Generals on Storage Systems and Comments on J2579 (5.2.2.1)

Hydrogen Fuel Cell Vehicle (HFCV)
4th Meeting of the Subgroup on Safety (SGS)
Tokyo
24th - 26th September 2008

5.2.2.1 “Extr. temp. gas cycle test”

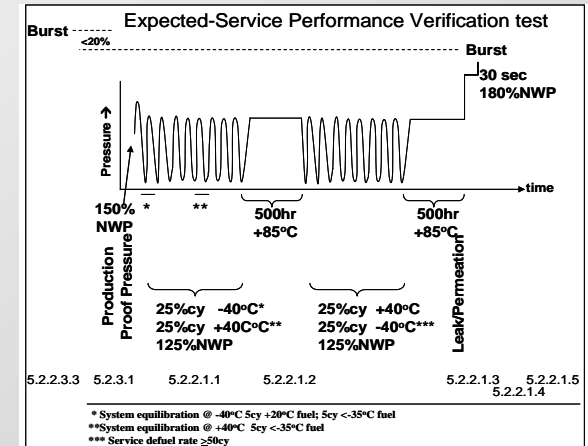
This test concept can be supported as best method for simulation the composite degradation process during use, if the following questions can be affirmed:

1. Is the filling procedure at fuelling stations harmonised enough to enable a description of test parameters such that the most critical degradation aspects are covered?
2. Does the ultimate criteria of 180% of NWP cover reliably the specific scatter of UTS of all cylinders with CFRP or other fibres?
3. How to ensure that one specimen can present the behaviour of all containers?
4. How to prevent a sudden burst during gas cycling such that the test facilities can be built up like a hydraulic test facility?

5.2.2.1 “Extr. temp. gas cycle test”

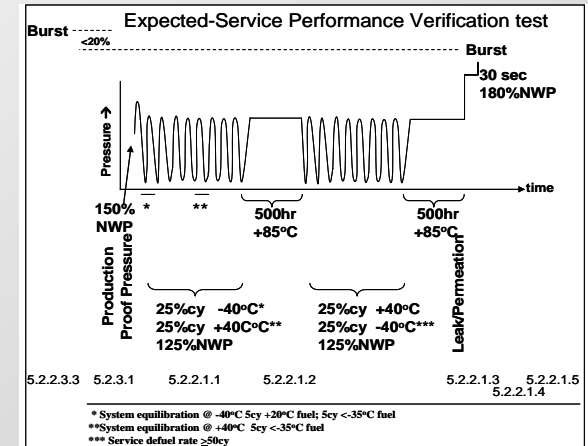
This test concept seems to be the best method to simulate the composite degradation process during use. But....

6. ... the test is extreme expensive to be performed on an adequate number of samples or to be repeated periodically during production.
7. ... the necessary test equipment (extreme ambient temperatures during filling procedure gas cycling) is commercially not available in an adequate number.
8. ... the concept of final burst tests in general may be appropriate for type IV-cylinders; It is not sufficient for cylinders with load sharing liners. At those the remaining strength of fatigue strength (scatter of cycles) or a critical change of residual stresses can not be detected.

Hydraulic Cycle Conditions of Type III

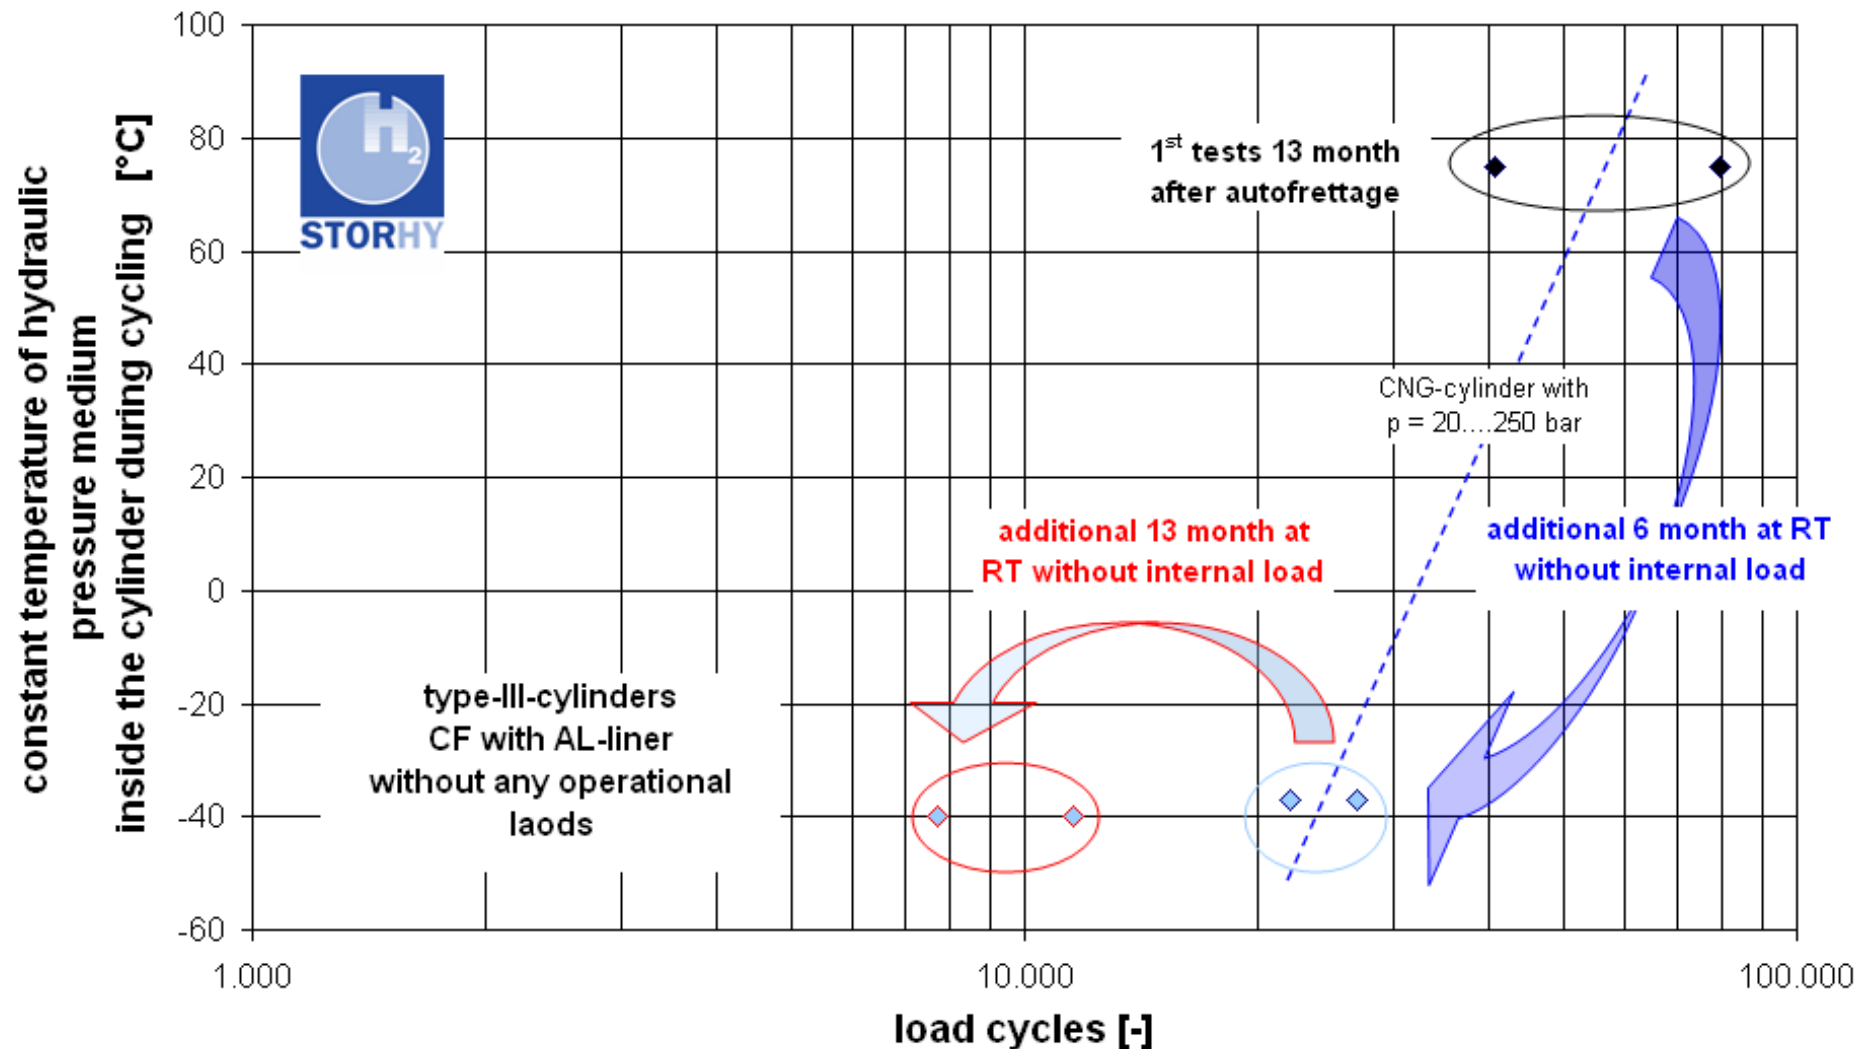
These test results show ...

- ... a significant influence of the **temperature** during cycles.
- ... unexpected influence of the **storage time** before cycling.

But it is currently not possible to confirm that the conclusion on the first view (it looks like a strong degradation of fatigue life without any pressure loads) is correct!

Type III: Residual Stresses

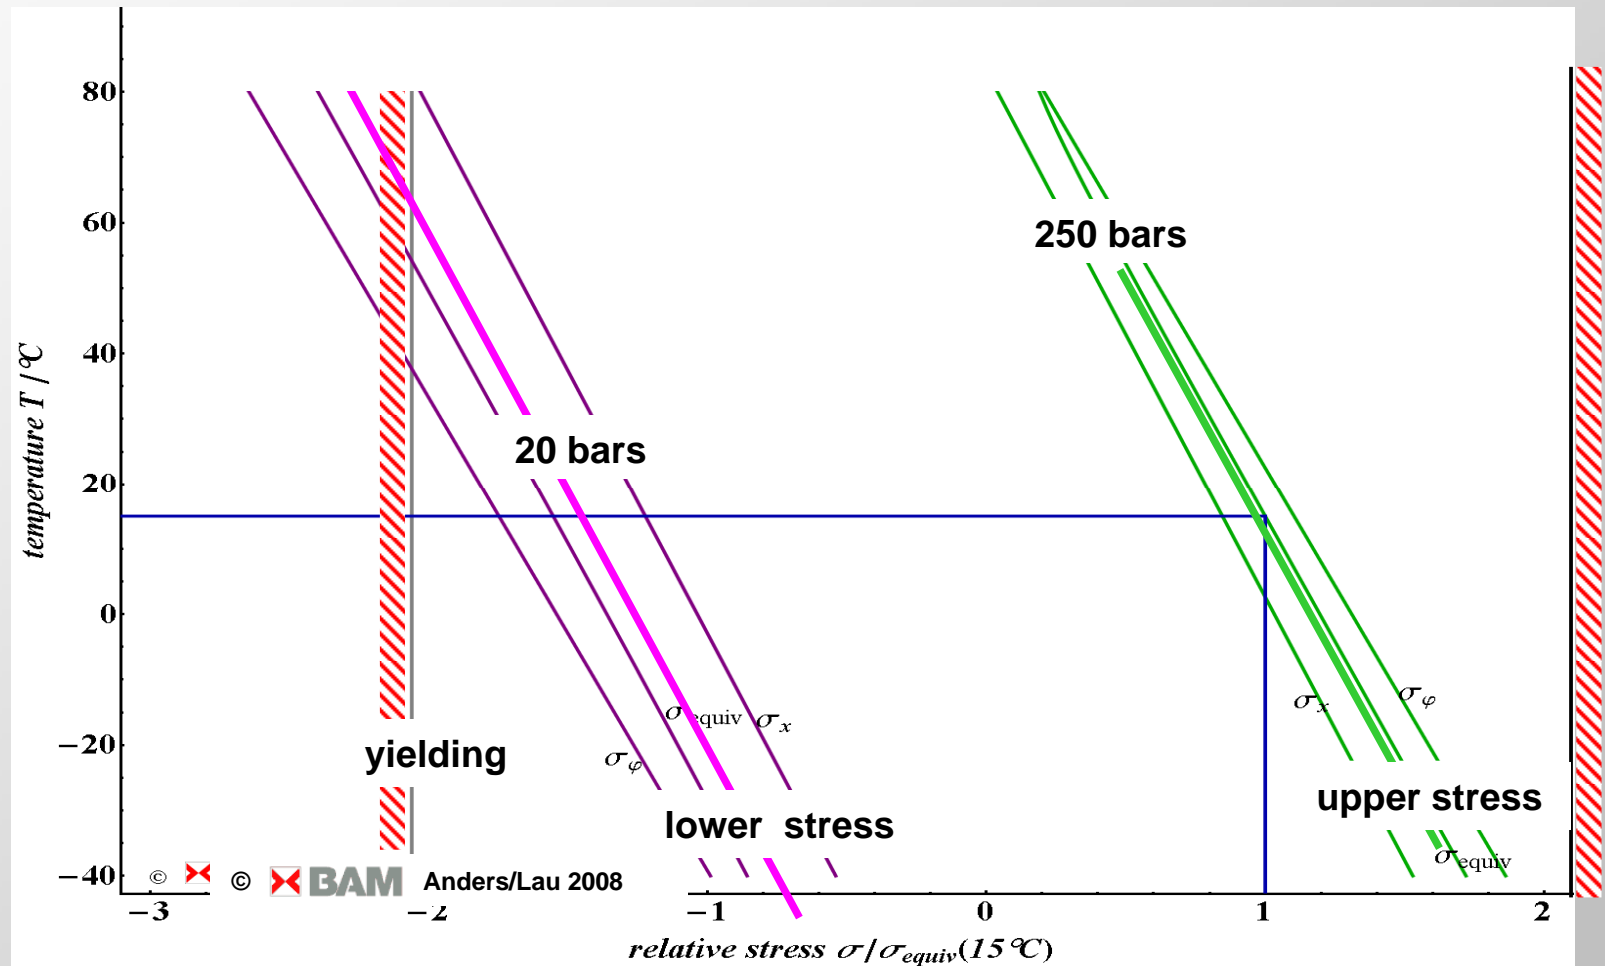
The upper and the lower stress levels (v. Mises) of a load sharing liner depends on temperature more than mostly estimated today.
